Addendum No. 03

Memorial Stadium Modernization

Fieldhouse & Stadium

MADERA UNIFIED BID NO.: 073025
PBK PROJECT NO.: 20-51
DSA APPLICATION NO.: 02-121624 Fieldhouse
02-122784 Stadium

C5.1

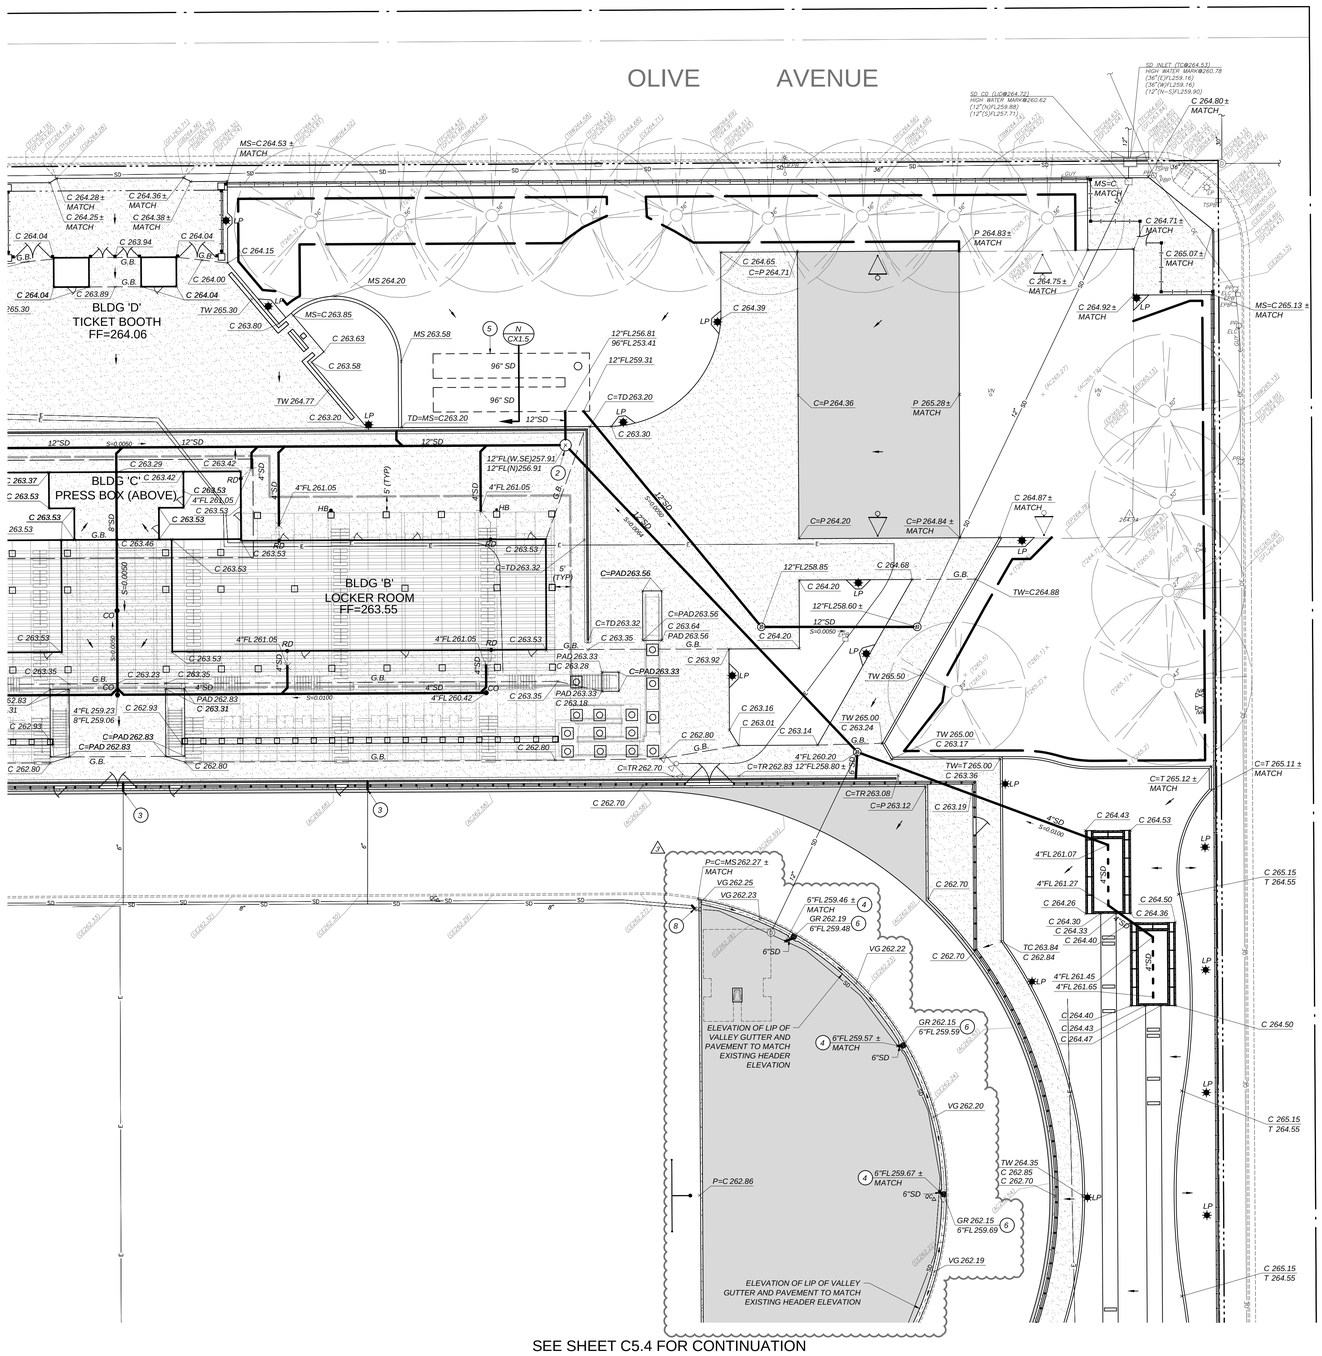
- Included ‘AE’ and GR’ in legend.
d. C5.1 – C5.4 GRADING AND DRAINAGE PLAN (4 pages)
   - Revised grading for concrete valley gutter.
   - Included grading for storm drainage system.

- Included notes 6,7, and 8 in Grading and Drainage Legend.
   - Added detail A/C5.1.
e. C7.1 – TRACK AND FIELD STRIPING PLAN
   - Revised field “D” end areas.

I CX1.7 EXISTING PERFORATED STORM DRAIN PIPE
NOT TO SCALE

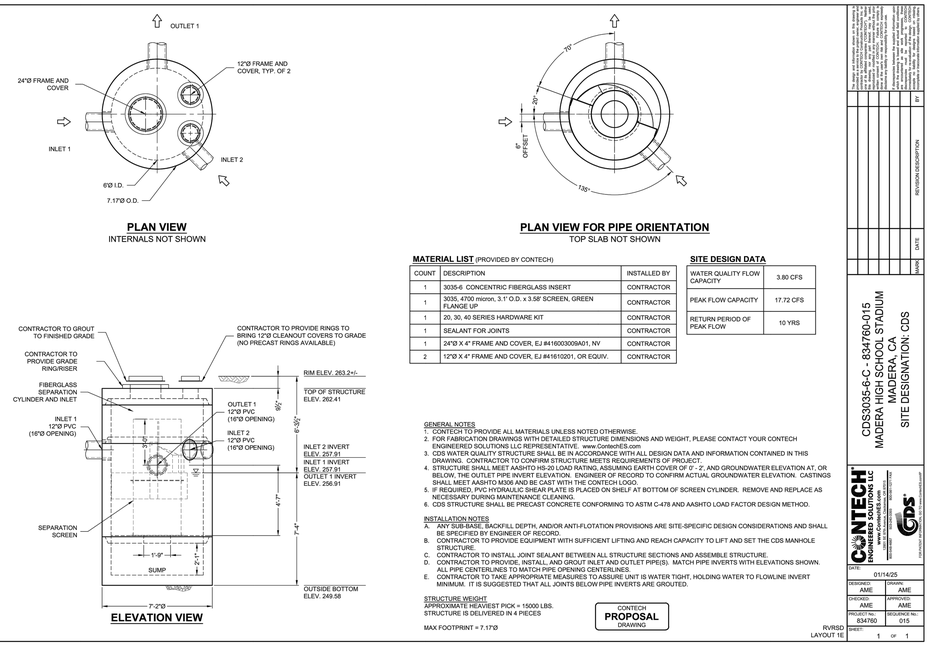
- Included detail I/CX1.7 “Existing Perforated Storm Drain Pipe”.

AS.1

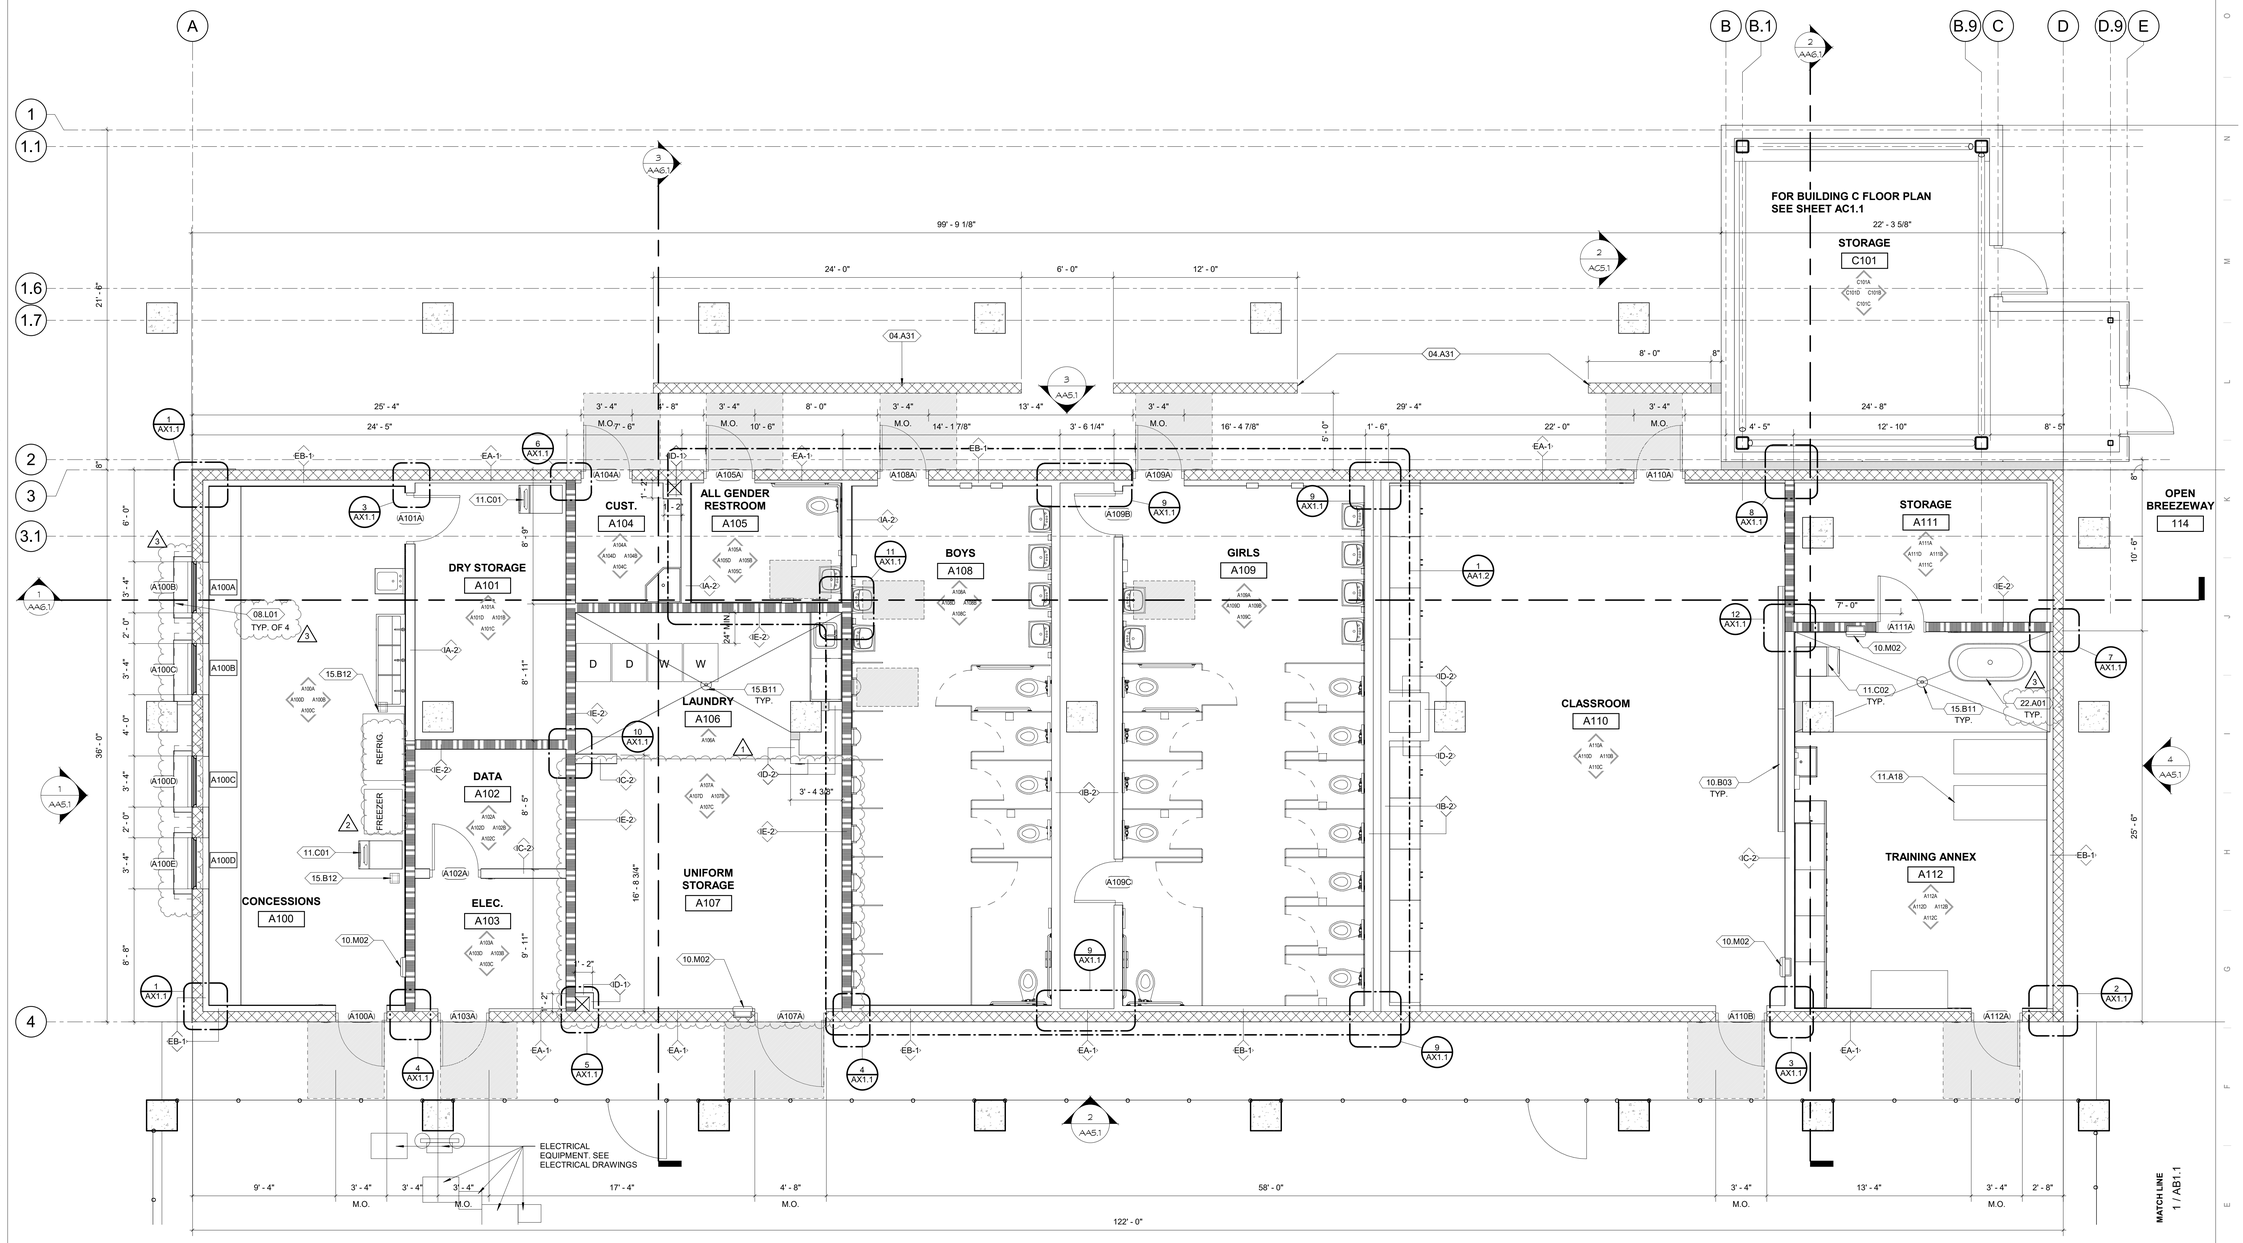
a. AS.1 – OVERALL SITE PLAN
   - Revised site gates.
b. AA1.1 – FLOOR PLAN - BUILDING A
   - Added countertops at exterior side of Concessions transaction windows.

AA1.1

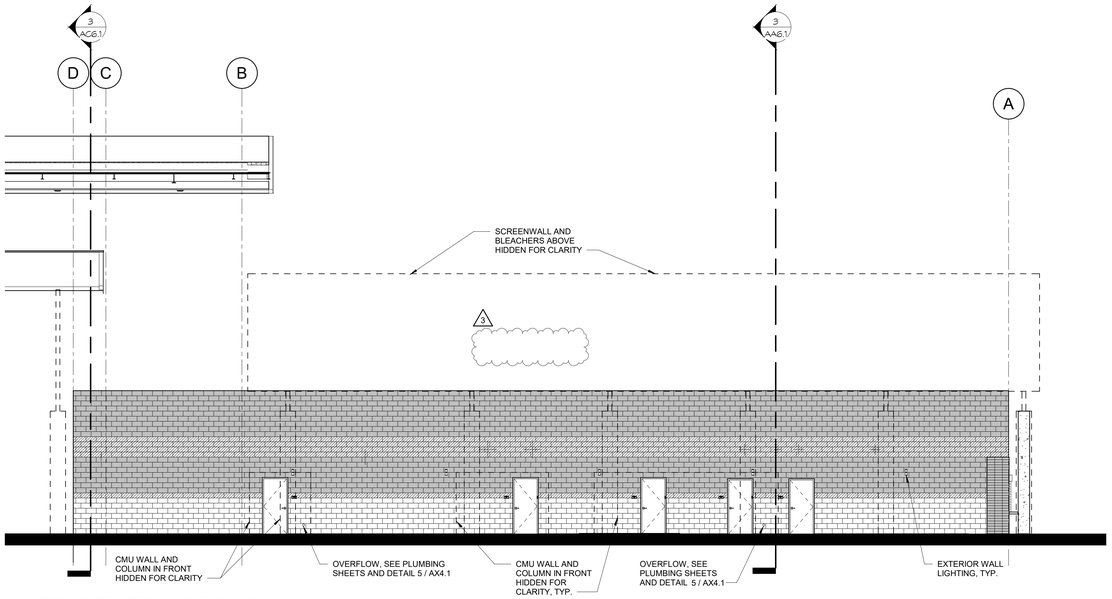
- Revised Keynotes.
c. AA5.1 – EXTERIOR ELEVATIONS - BUILDING A
   - Added countertops at exterior side of Concessions transaction windows
   - Relocated overhead coiling doors to exterior side of concessions.

AA5.1

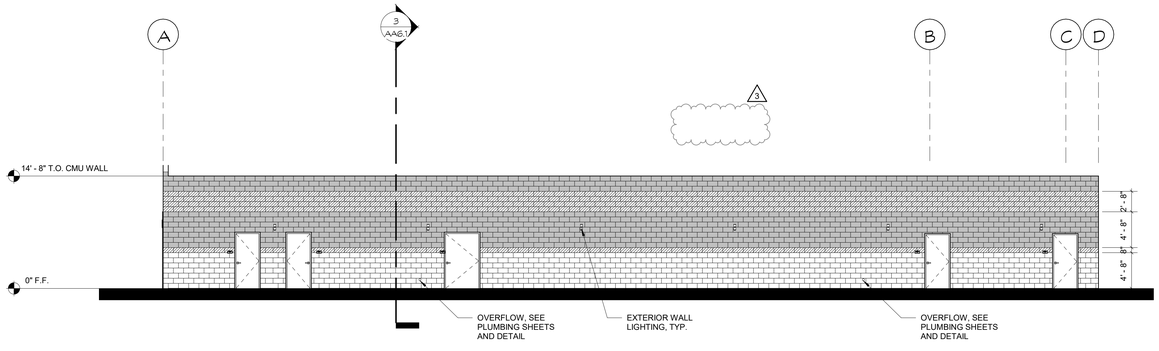
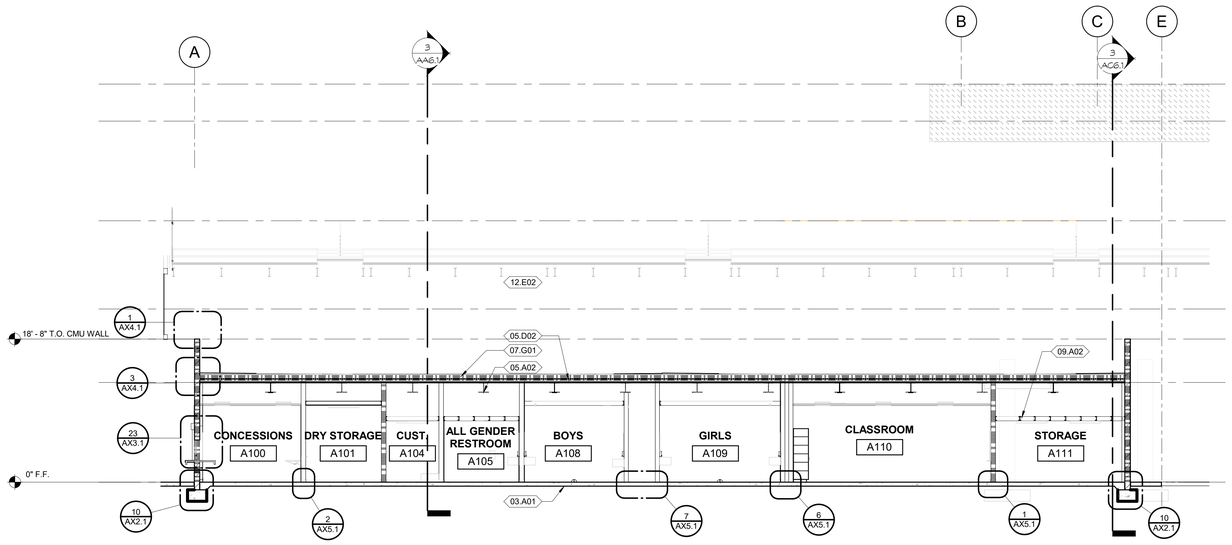
- Removed CMU control joints.
d. AA6.1 – BUILDING SECTIONS - BUILDING A
   - Revised General Notes.
e. AA7.1 – INTERIOR ELEVATIONS - BUILDING A
   - Revised Concessions interior elevations.

AB5.1

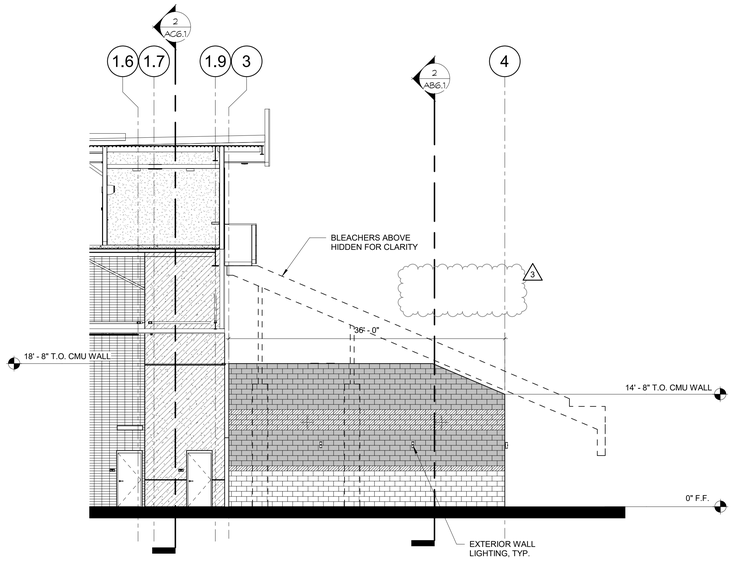
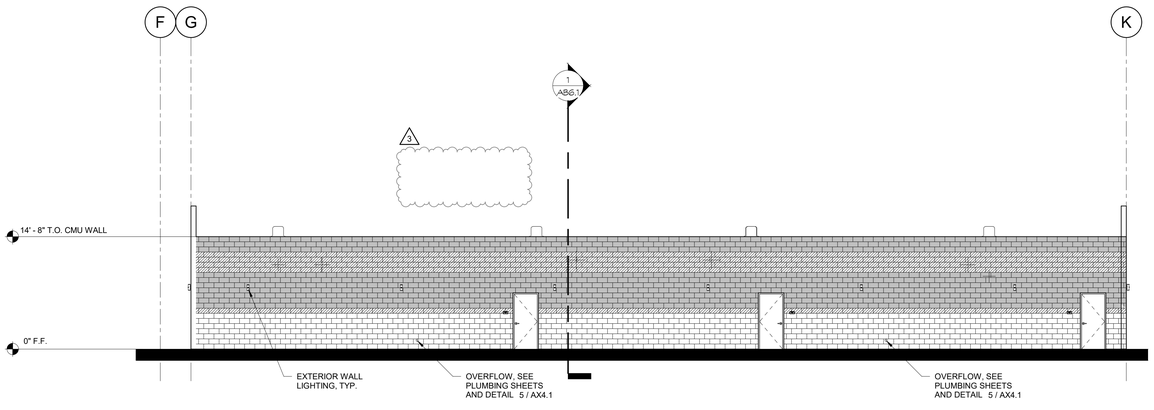
f. AB5.1 – EXTERIOR ELEVATIONS - BUILDING B
   - Removed CMU control joints note on elevations.
g. AB6.1 – BUILDING SECTIONS - BUILDING B
   - Revised General Notes.

AC5.1

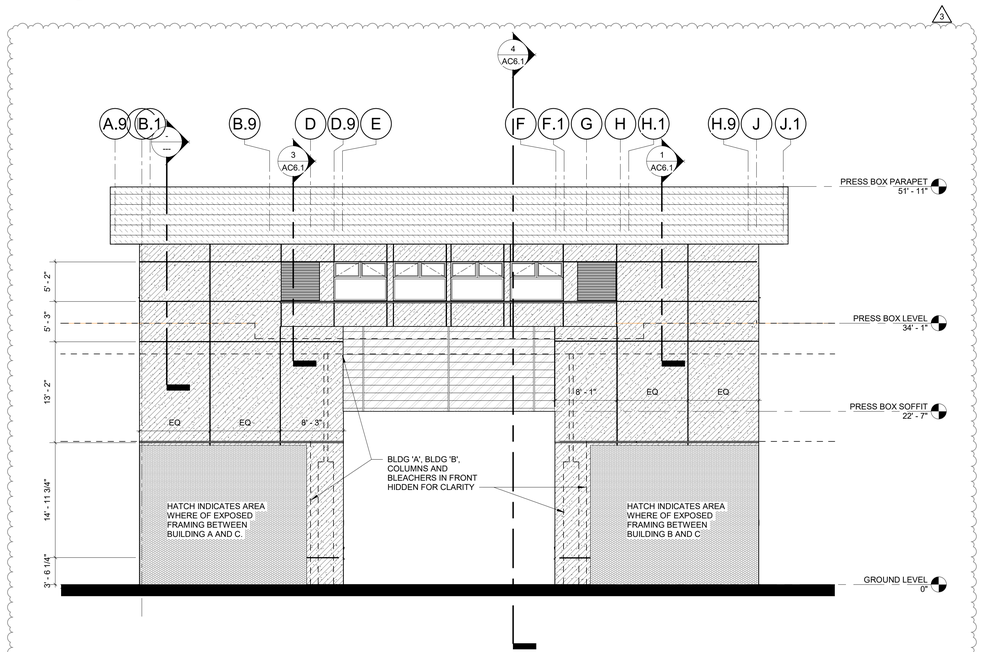
h. AC5.1 – EXTERIOR ELEVATIONS - BUILDING C
   - Revised South Elevation.
   - Added elevation 05 and 06.
i. AC6.1 – BUILDING SECTIONS - BUILDING C
   - Revised General Notes.

AD5.1

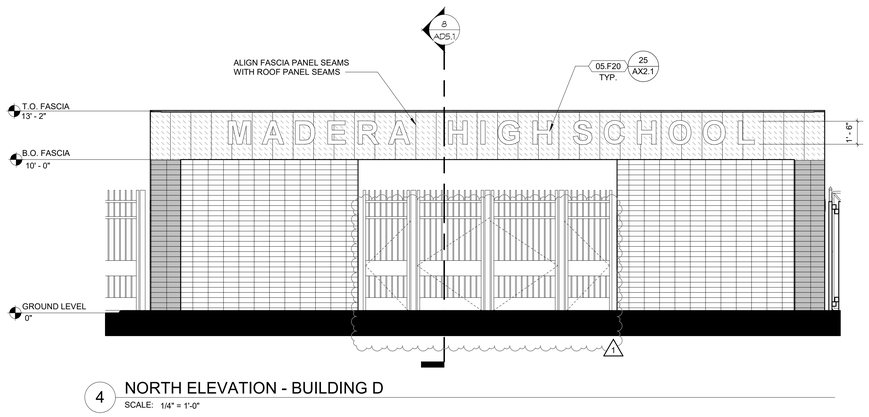
j. AD3.1 – ENLARGED RCP - BUILDING D
   - Revised Ceiling height and Legend.
k. AD5.1 – ELEVATIONS & SECTIONS - BUILDING D
   - Revised transaction window type.

- Added mechanical louvers.
   - Added note to elevation.
l. AD7.1 – INTERIOR ELEVATIONS - BUILDING D
   - Revised transaction window type.
   - Added mechanical louvers.

AX8.1

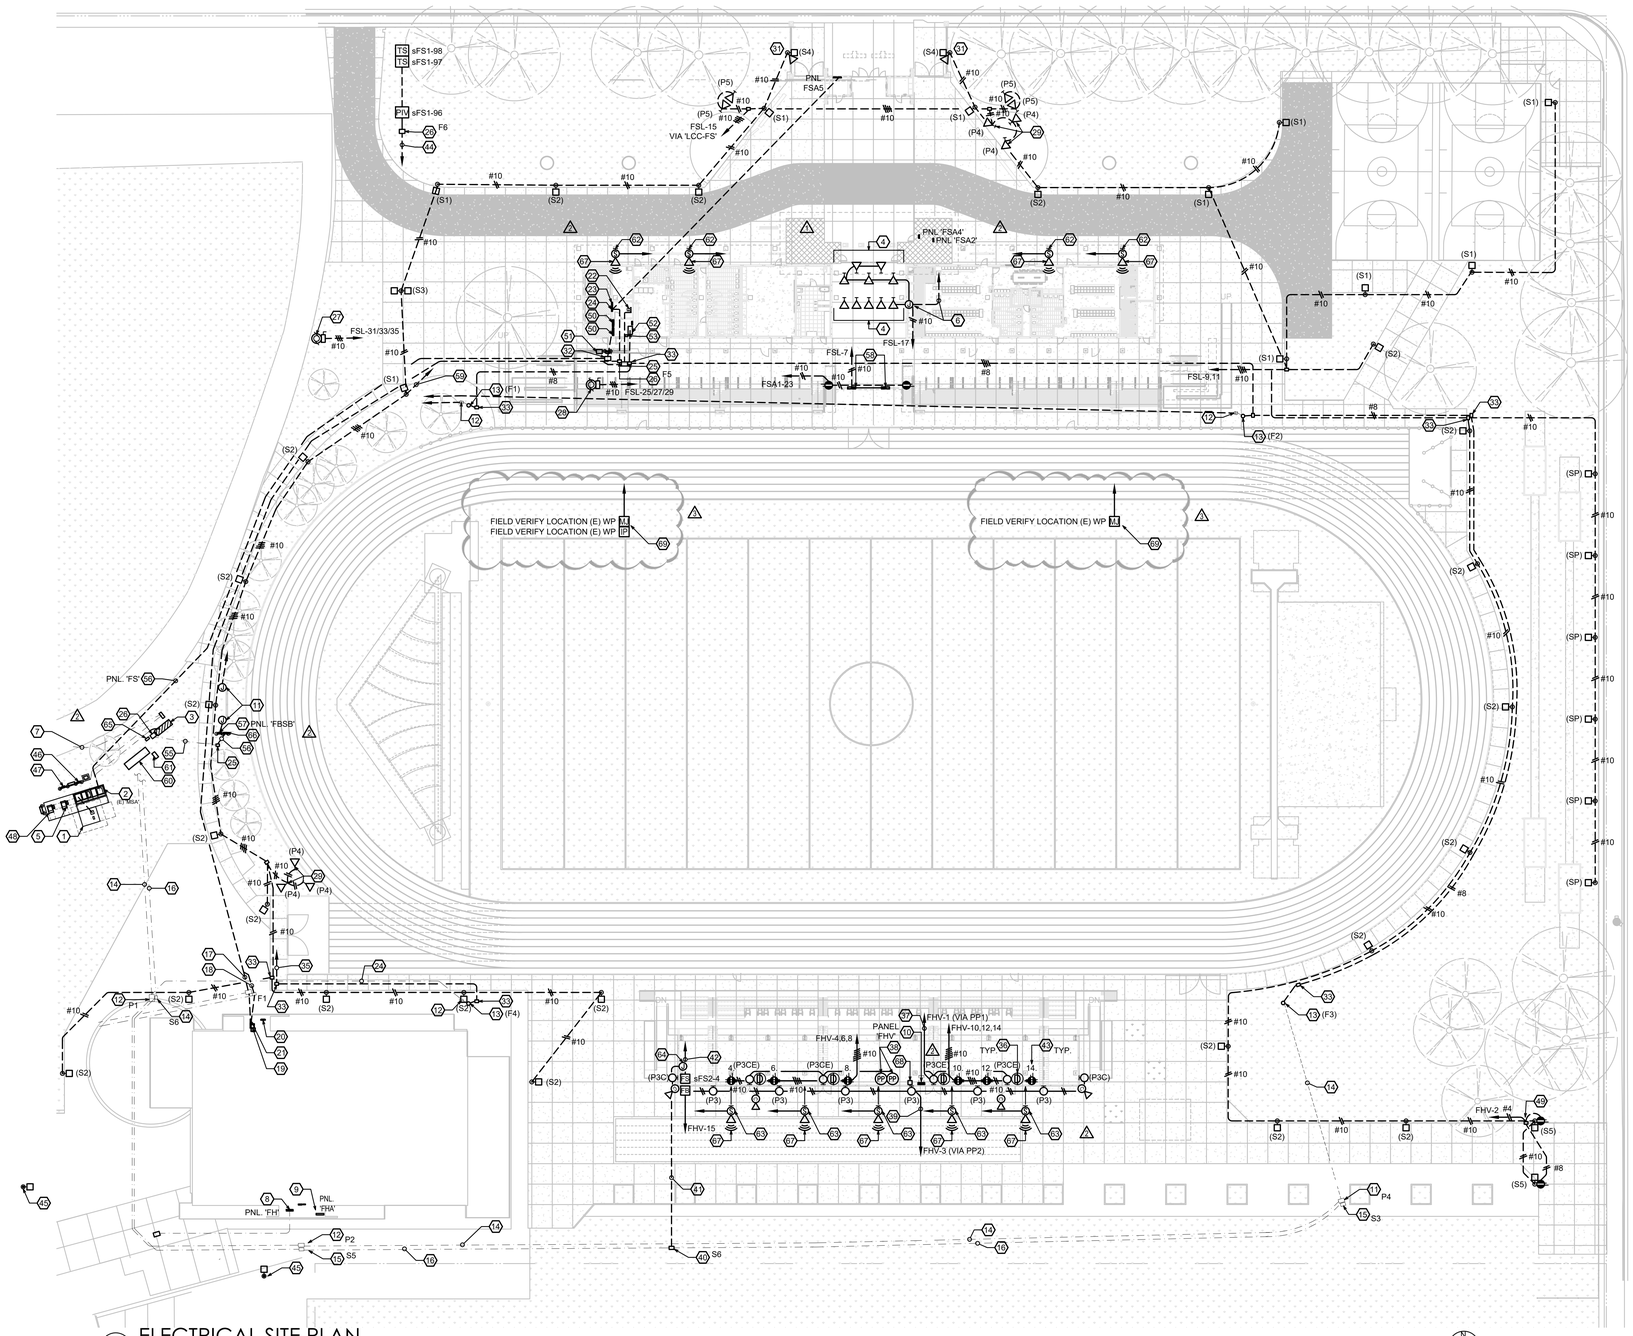
t. AX3.2 – TYPICAL OPENING DETAILS – STOREFRONT
   - Removed z-girts from details 05 and 14.
u. AX4.1 – ROOF DETAILS
   - Revised note on detail 10.
v. AX8.1 – DOOR AND WIDNOW SCHEDULE
   - Revised door types and window types.
